Technical BULLETIN

SAFETY RECALL

CERTAIN 2022-MODEL XTZ7N (TÉNÉRÉ 700) MOTORCYCLES FACTORY MODIFICATION CAMPAIGN – Incorrect Brake Caliper Bolts

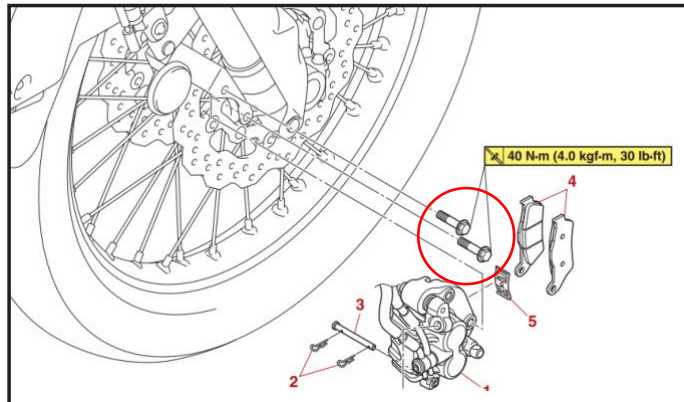
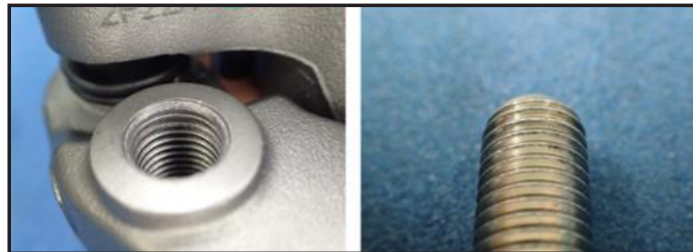
1. On one side and then the other, remove and measure the thread length of the front brake caliper bolts as indicated. The bolt threads should be 20 mm long on a bolt that is 40 mm long. **Any other dimensions are incorrect, and the bolt should be replaced.**

- If both bolts are correct, reinstall and tighten them to the specified torque.

- If either bolt or both bolts are incorrect, clean the mounting hole threads in the caliper. Visually inspect the threads for damage and use a clean bolt of the correct type to see if it can be threaded into the hole smoothly.

Mounting Bolt: 40 Nm (4.0 kgf-m, 30 lb-ft)

- Install the bolts, using new bolts to replace any incorrect ones. Tighten the bolts to the specified torque.

Mounting Bolt: 40 Nm (4.0 kgf-m, 30 lb-ft)
